Update to Bid Documents – May 20, 2025

VAMC St. Cloud, MN
Remodel Building 51-1 Eastside
4801 Veterans Drive
St. Cloud, MN 56303

VA Project 656-19-307
May 20, 2025
Update to Bid Documents

DRAWING TITLE
FIRST FLOOR DEMOLITION PLAN

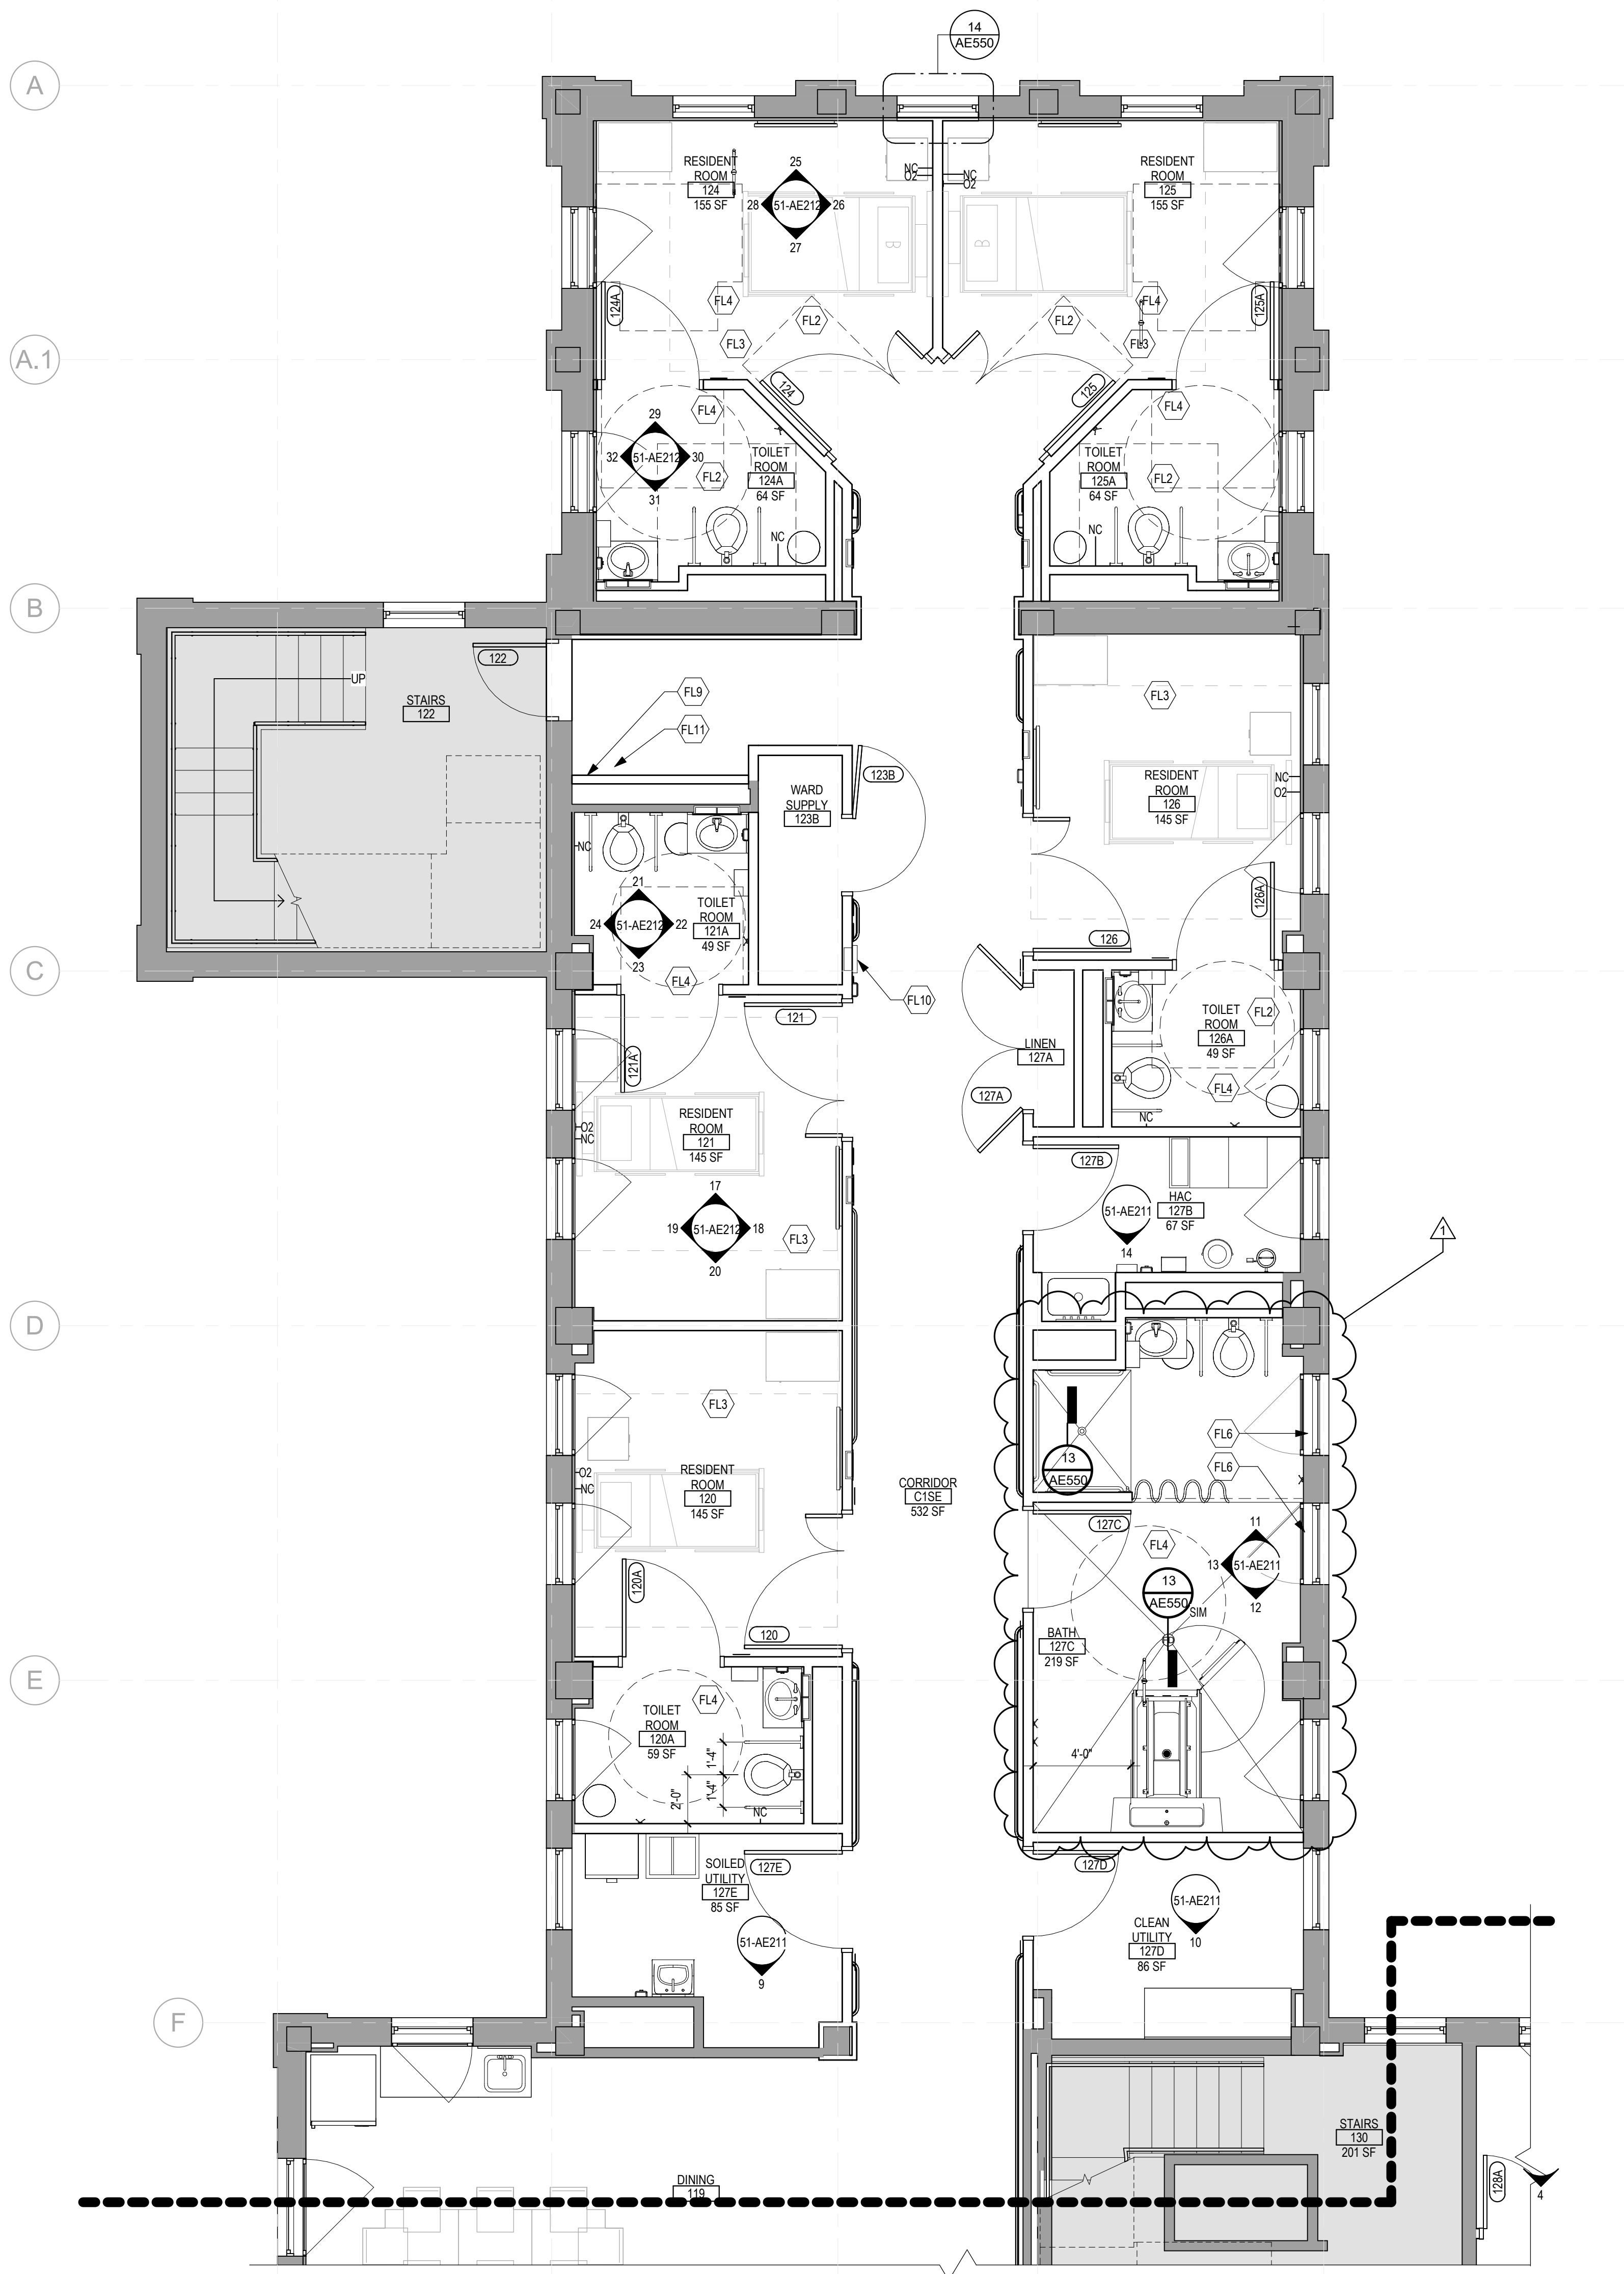
- c. REVISE keyed note 22
 - d. REVISE keyed note 23
 - e. REVISE keyed note 24
9. Sheet 51-AD111
 - a. REVISE drawing 1 - keyed note 20 shall apply to all spaces not hatched.

- b. REVISE drawing 1 – (7) overhead lifts identified for removal and salvage.
 - c. REVISE keyed note 20
 - d. REVISE keyed note 22
 - e. REVISE keyed note 23

- f. REVISE keyed note 24
10. Sheet 51-AE110 – Sheet not reissued
 - a. OMIT accessible note
11. Sheet 51-AE111
 - a. REVISE keyed note 8
 - b. REVISE drawing 1 – showing interior windows at bath 127C

1 51-1 FLOOR PLAN - ZONE 2
1/4" = 1'-0"

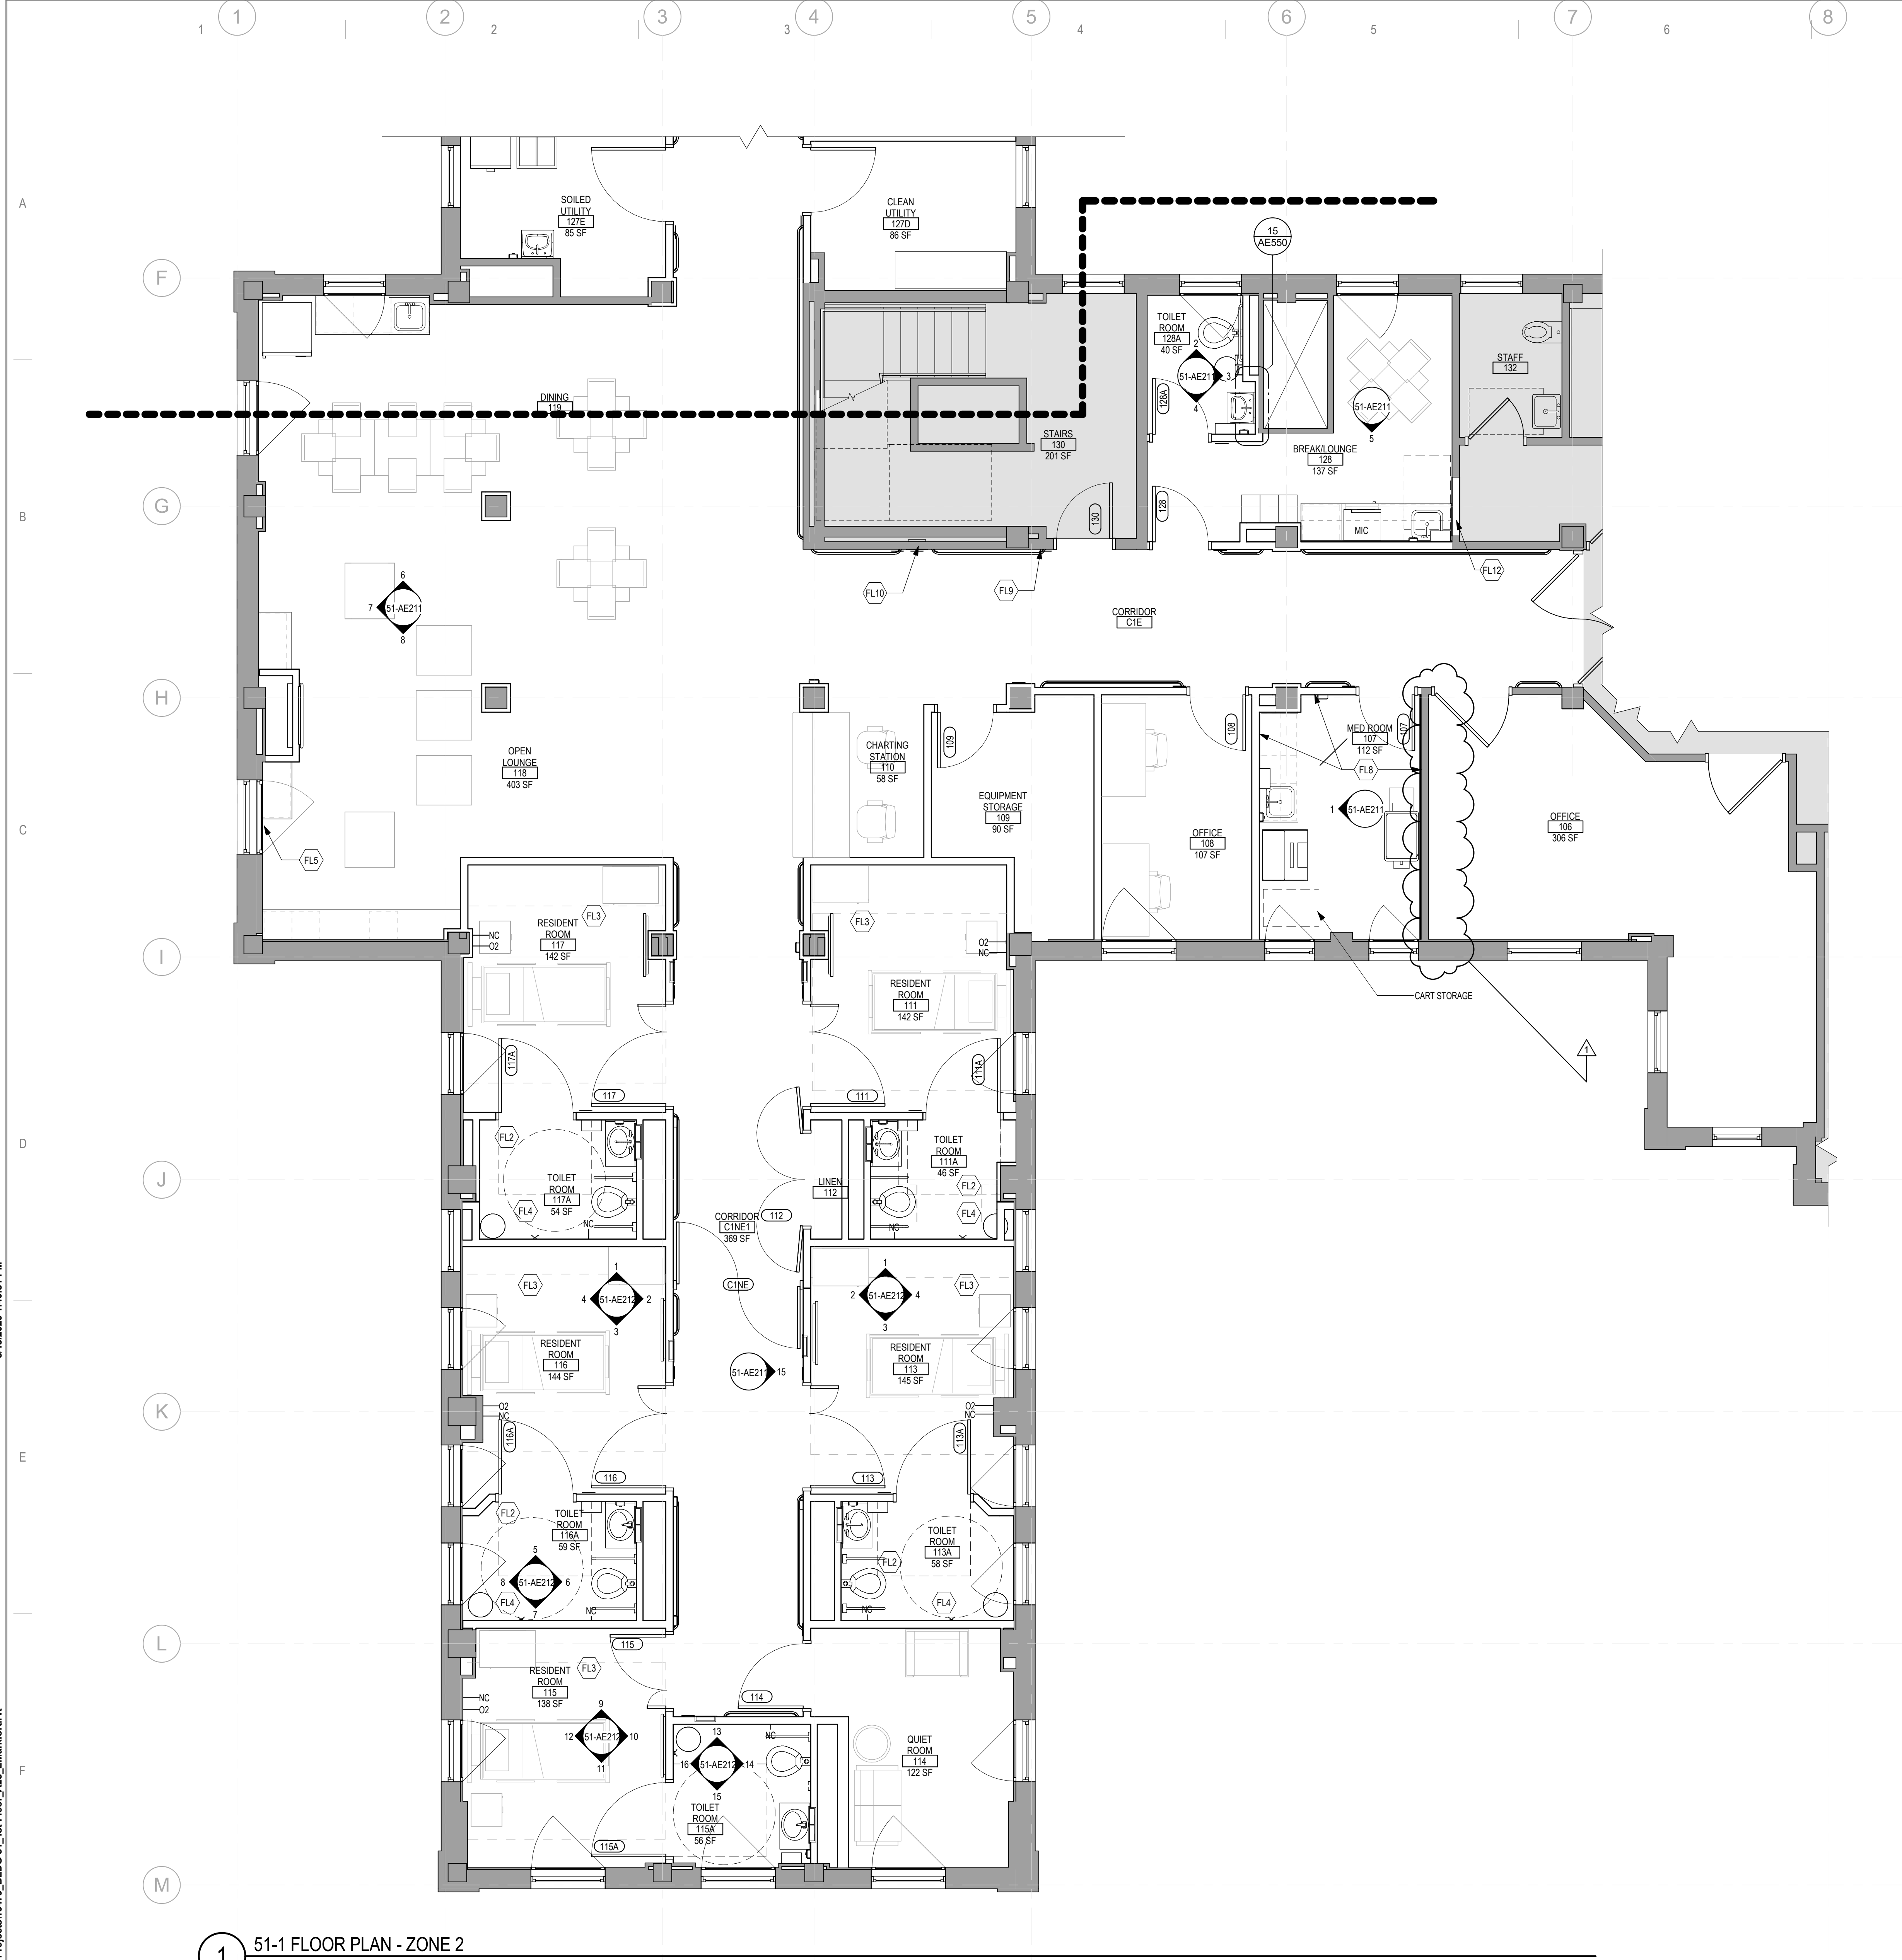
- c. REVISE drawing 1 – showing floor slop at bath 127C
12. Sheet 51-AE112
 - a. REVISE keyed note 8
 - b. REVISE drawing 1 – east partition medication room 107

1 51-1 FINISH PLAN - ZONE 1
1/4" = 1'-0"

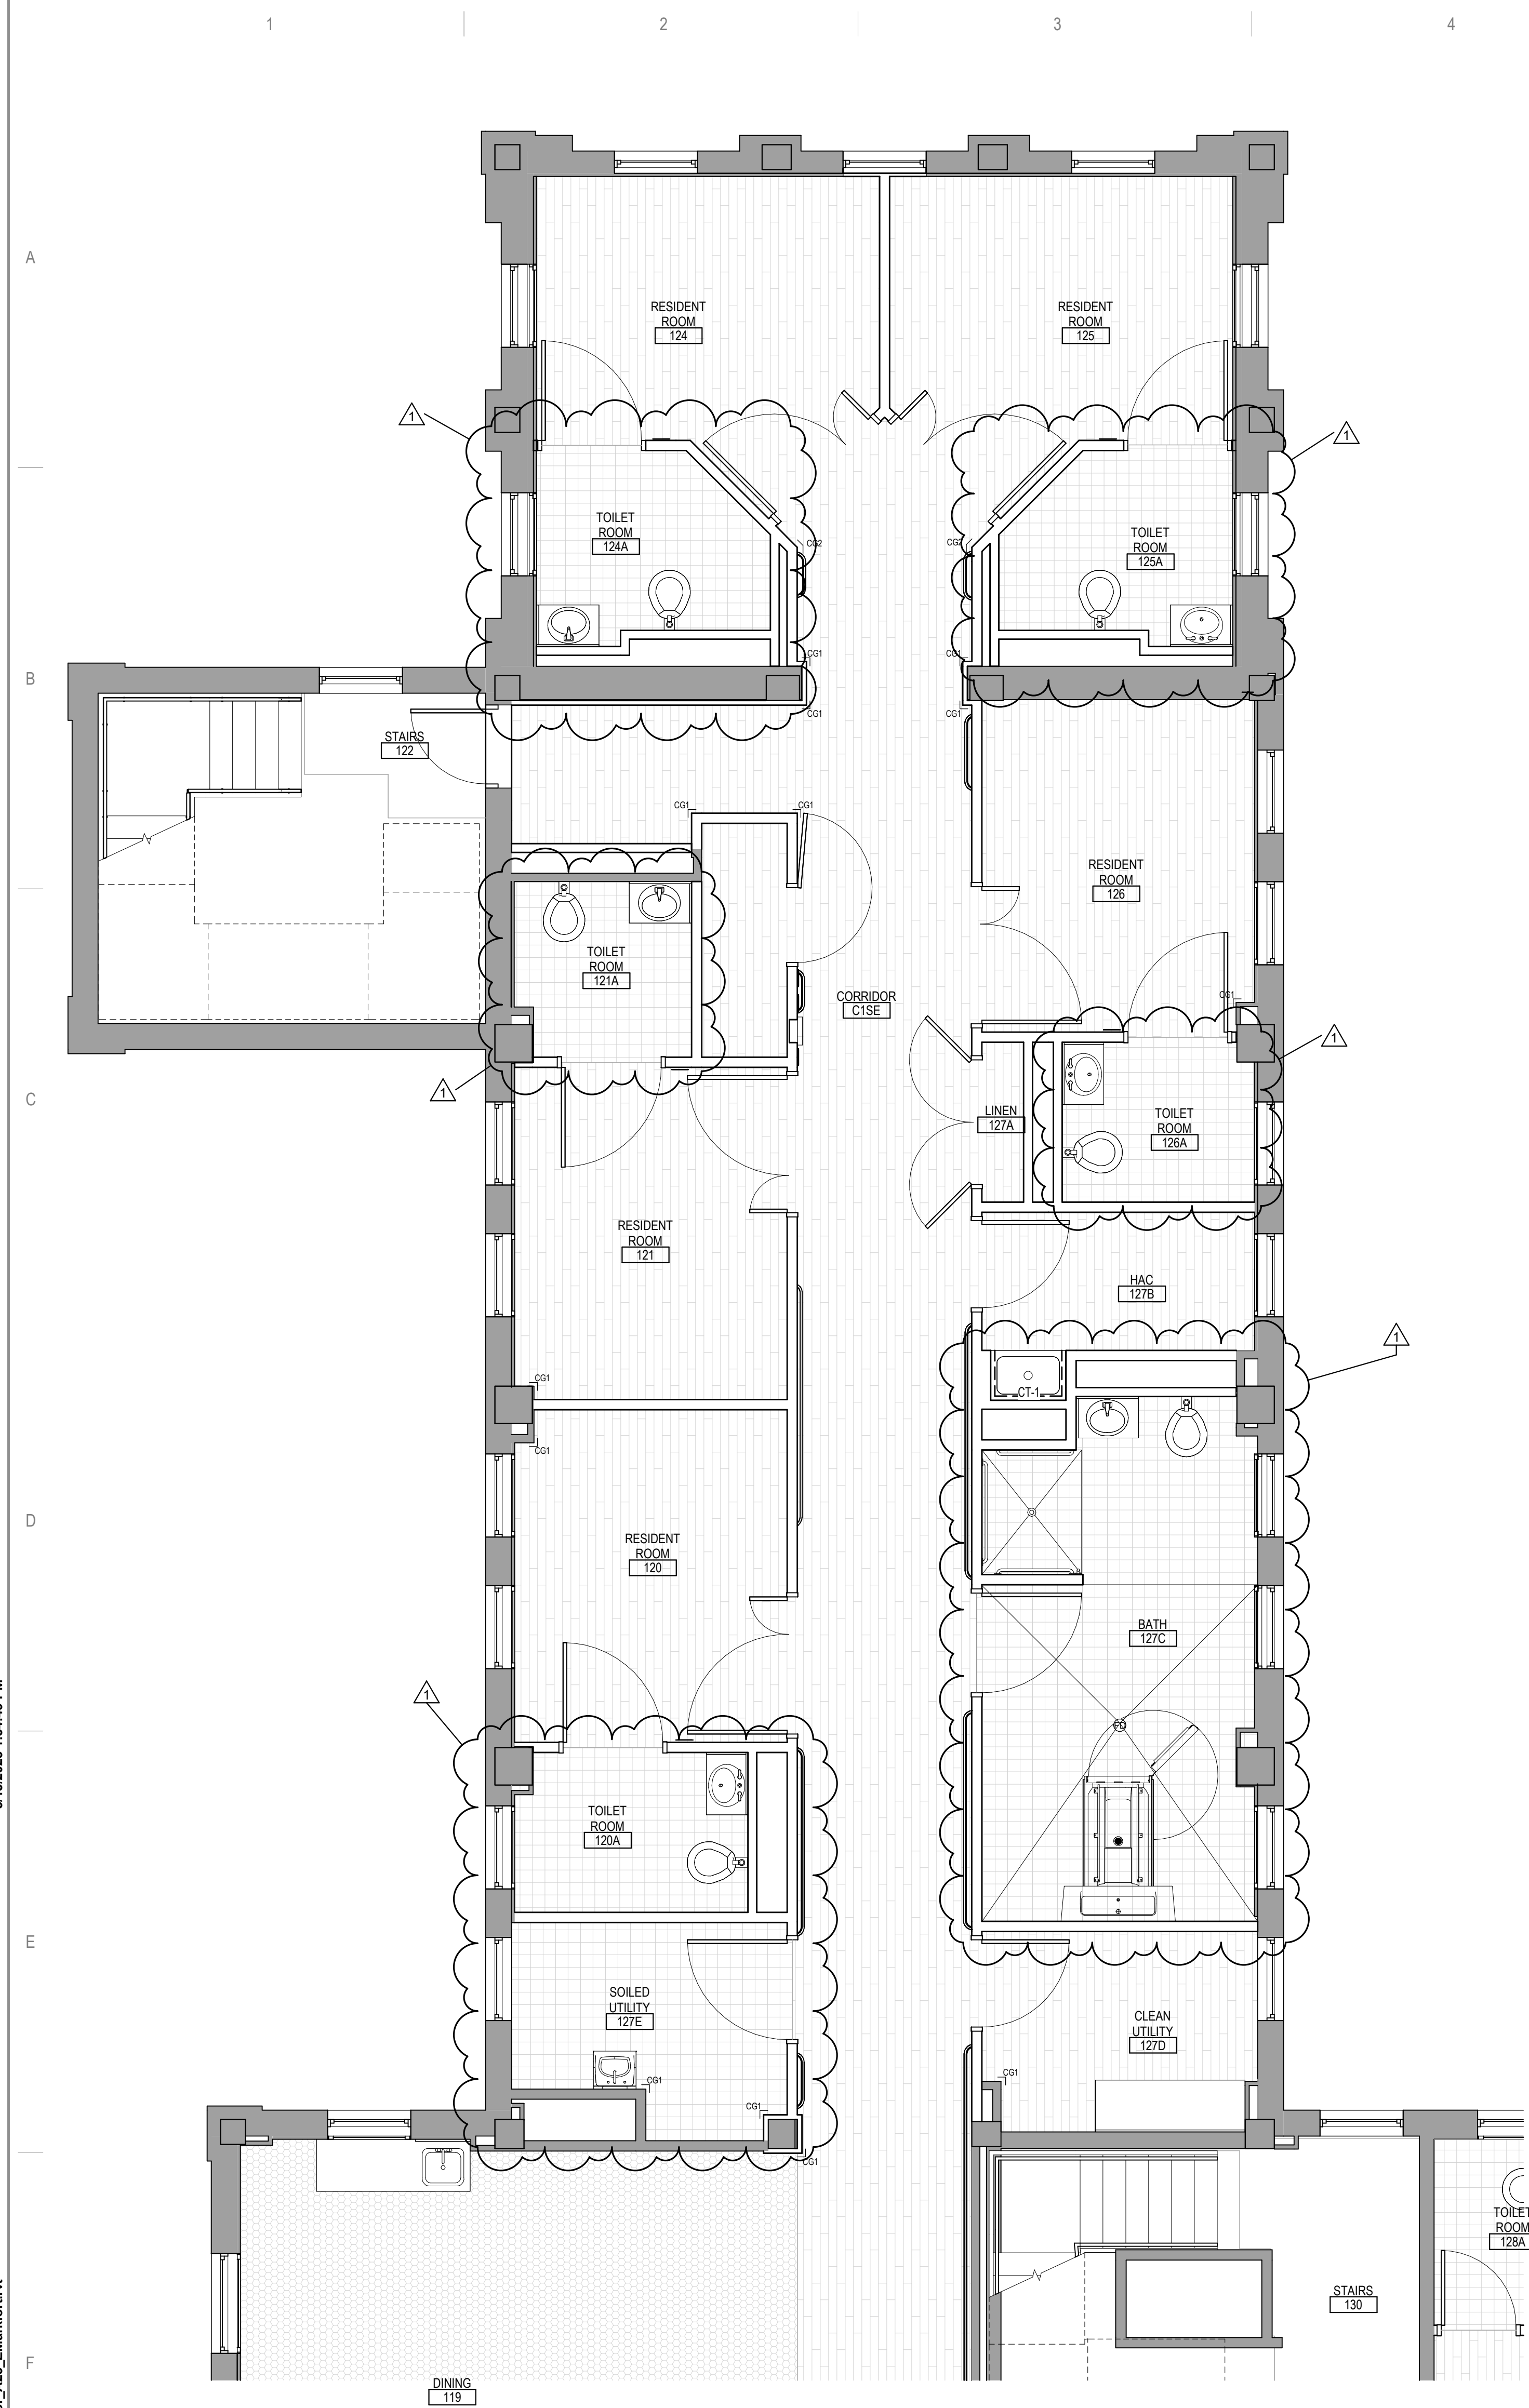
- 17. Sheet 51-AF110
 - a. REVISE floor finish at toilet rooms
 - b. REVISE floor finish at soiled utility
- 18. Sheet AF600
 - a. ADD paint and resilient base wall finish at 48-106B
